ATTACHMENT 2 TO AEP:NRG:1077B

PROPOSED TECHNICAL SPECIFICATION CHANGES

ATTACHMENT 3 TO AEP:NRG:1077B

DONALD C. COOK NCULEAR PLANT UNIT 1 CYCLE 11

FIGURE 3.1-2
Moderator Temperature Coefficient (MTC)

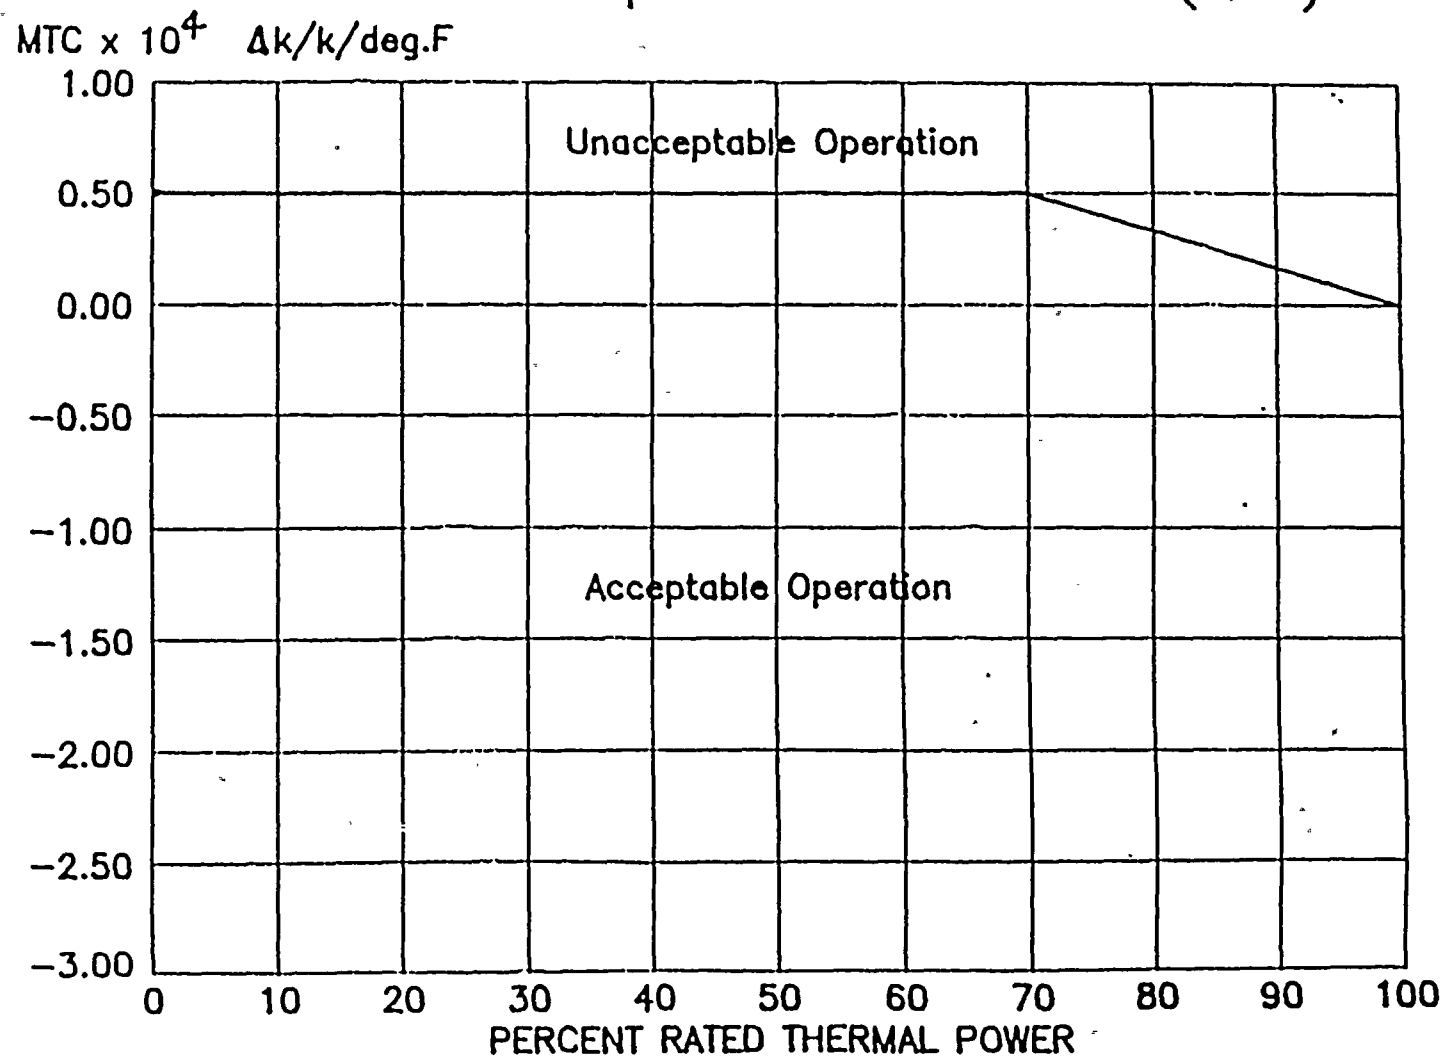
3.1.1.4 The moderator temperature coefficient (MTC) shall be within the limits specified in the COLR. The maximum upper limit shall be less than or equal to the limit shown in Figure 3.1-2.

FIGURE 1

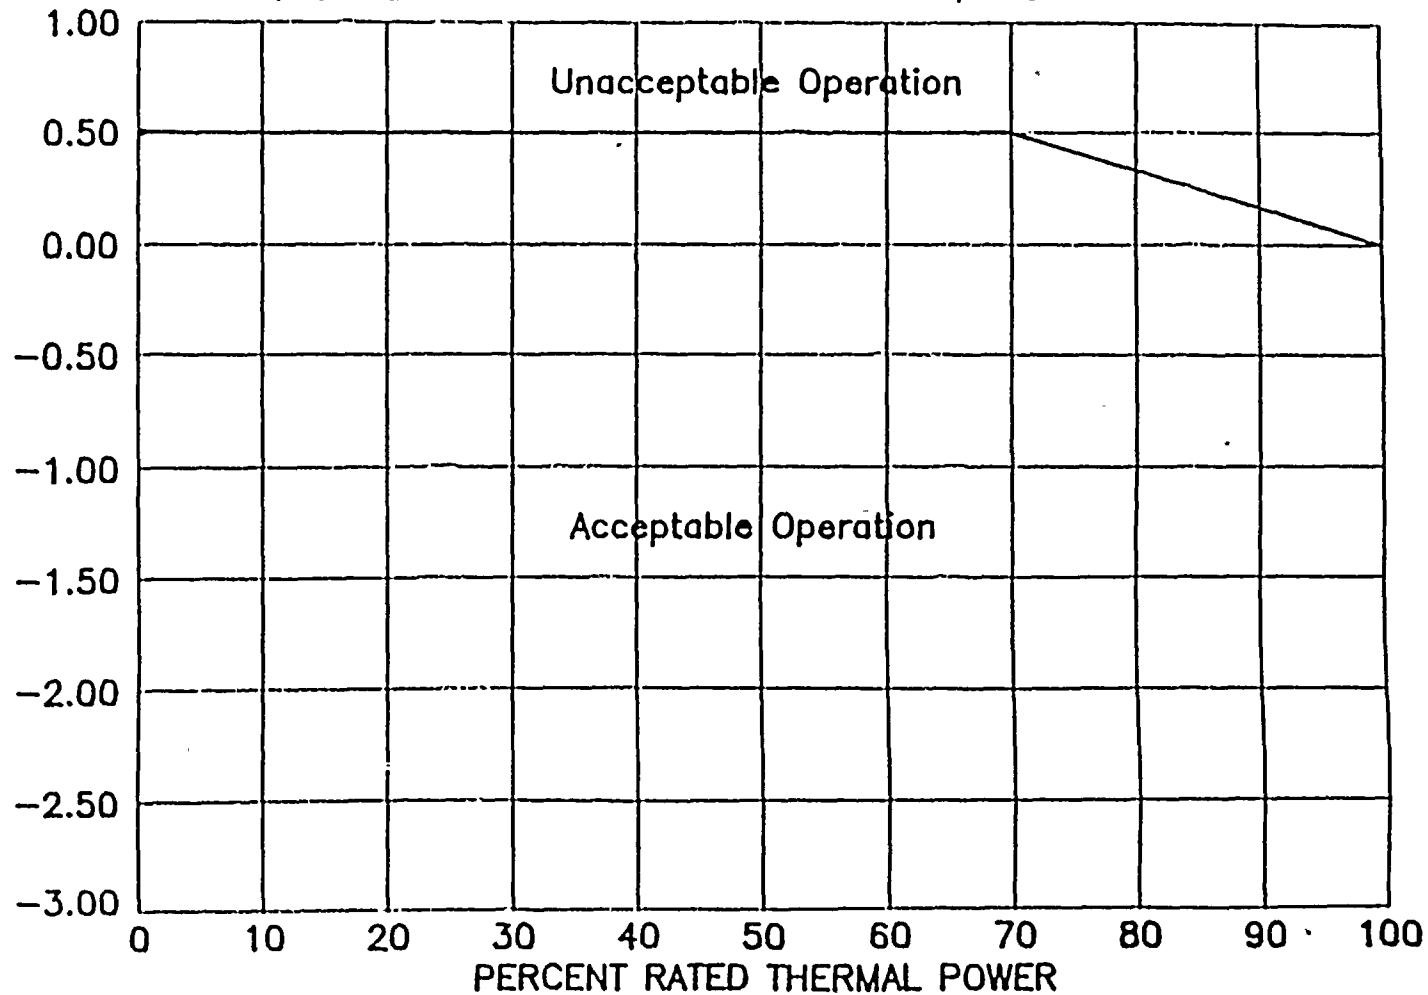
The BOL/ARO -MTC shall be less positive than the value given in Figure 1.

FIGURE 2

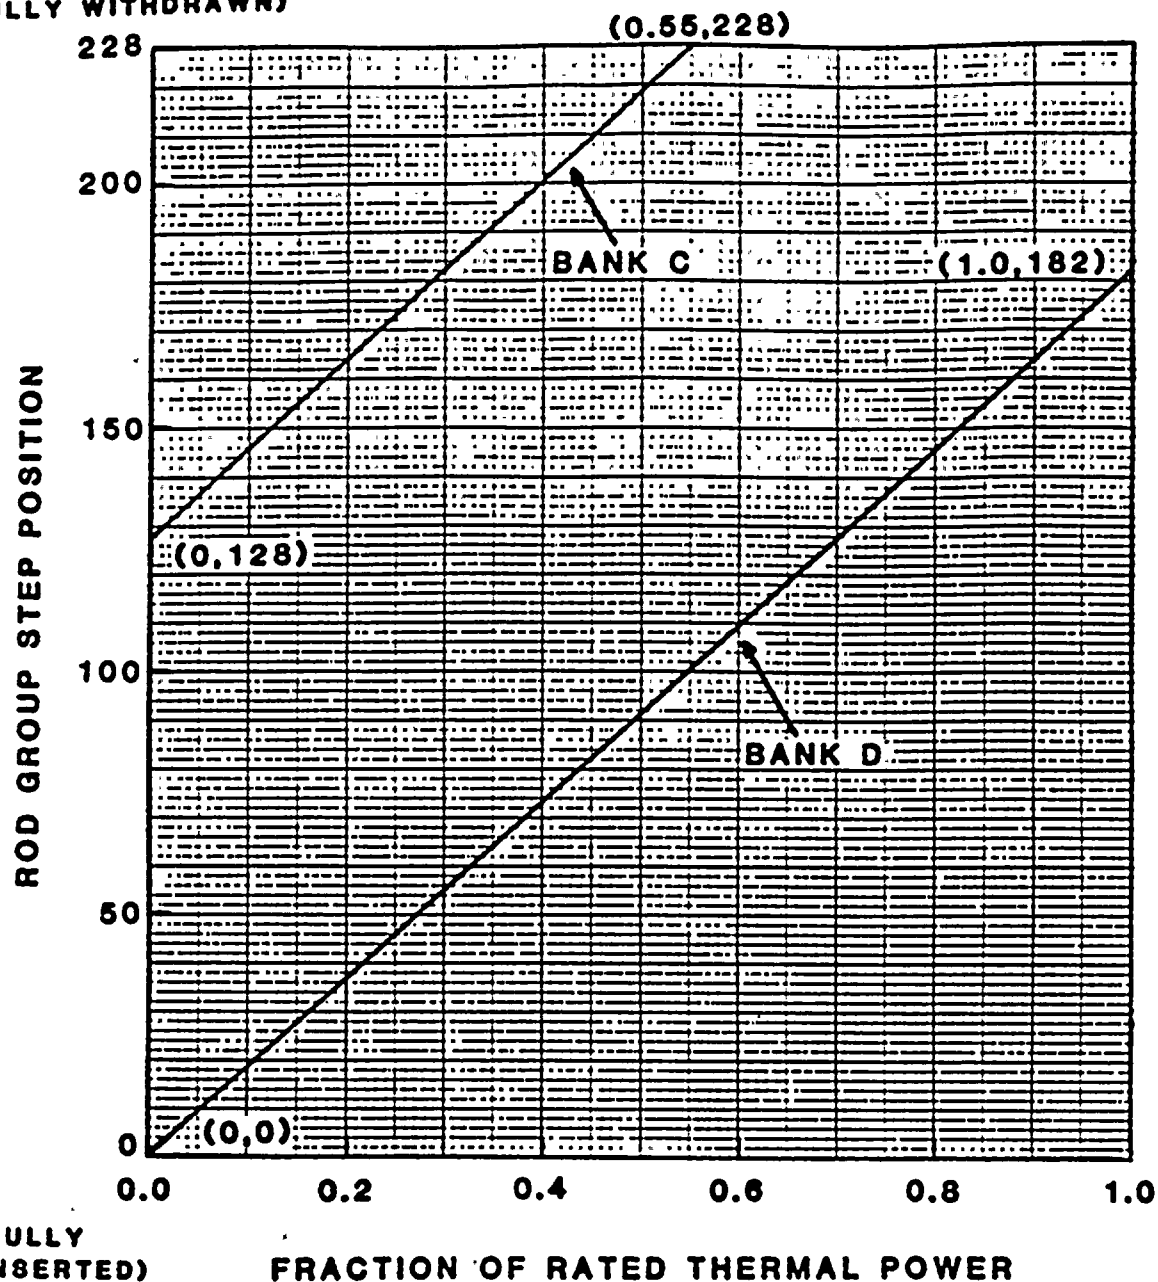
2.4.1 The control banks shall be limited in physical insertion as shown in Figure 2.

FIGURE 3
AXIAL FLUX DIFFERENCE LIMITS AS A FUNCTION OF RATED THERMAL POWER

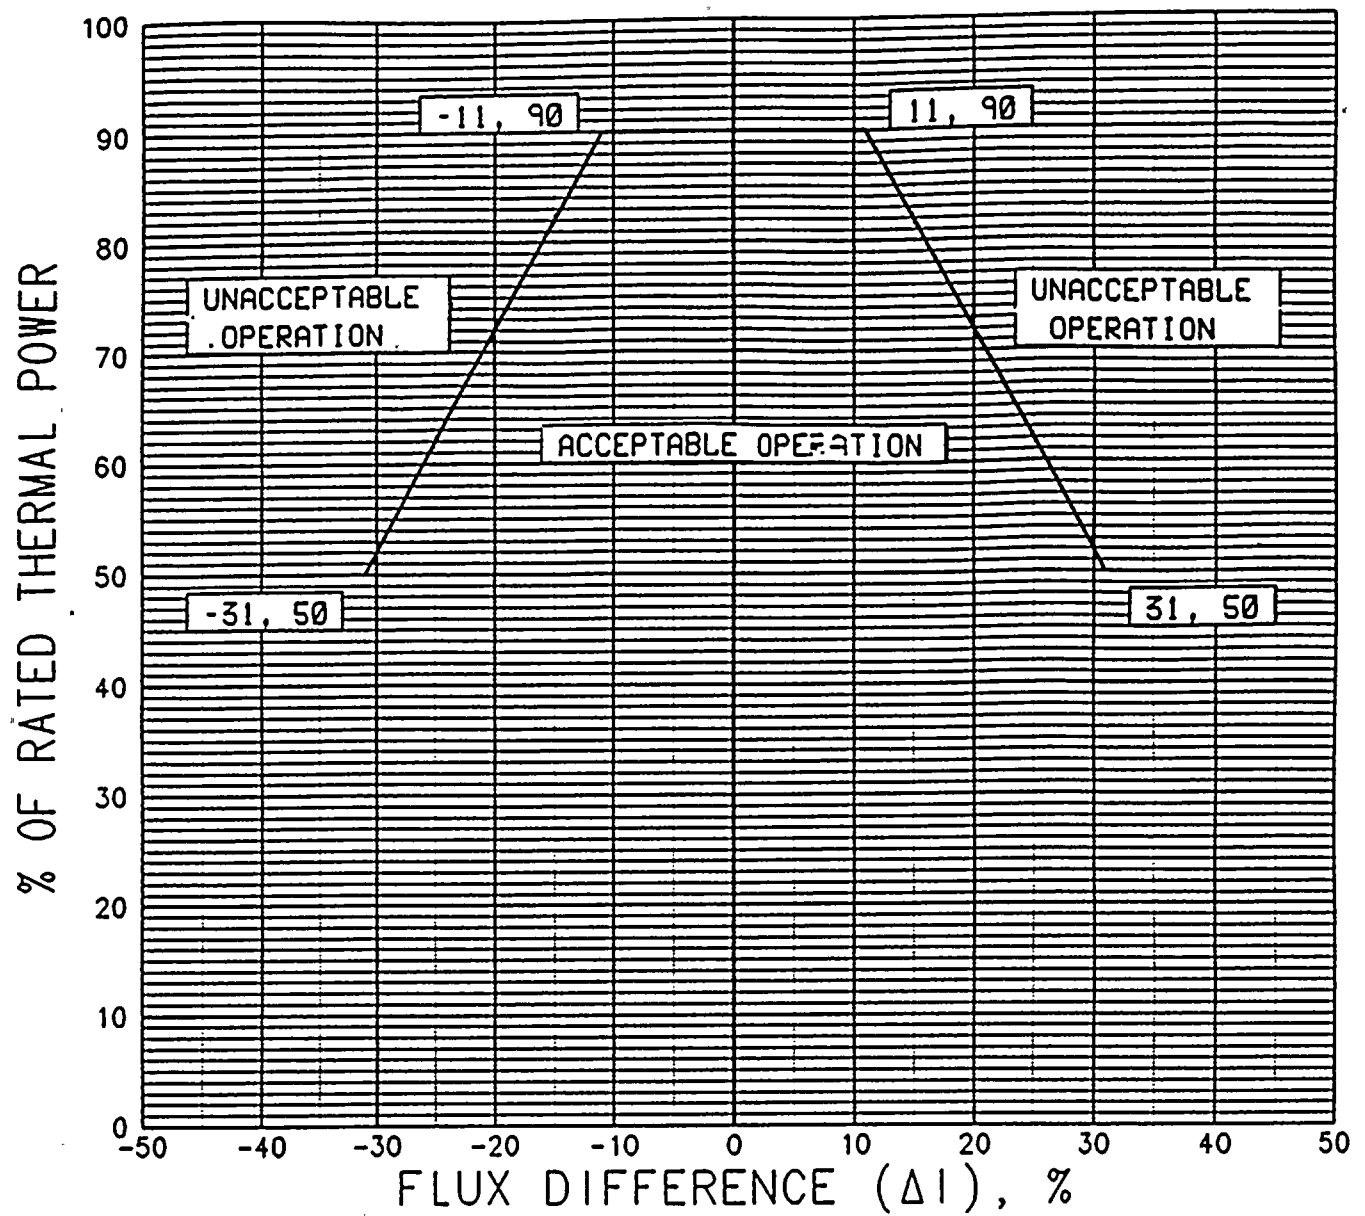
2.5.1 The Allowable Operation Limits are provided in Figure 3.

FIGURE 4

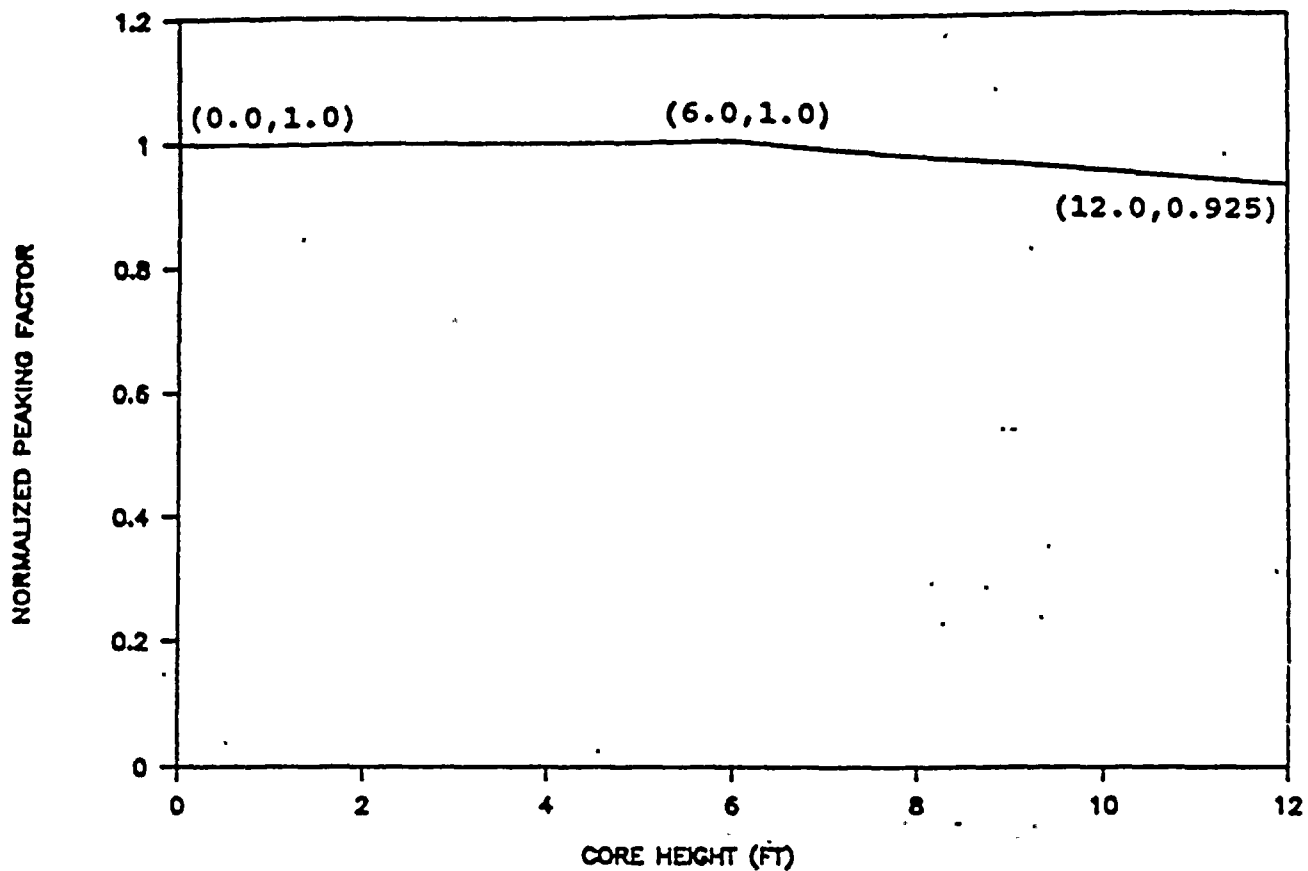
2.5.2 $K(Z)$ is provided in Figure 4
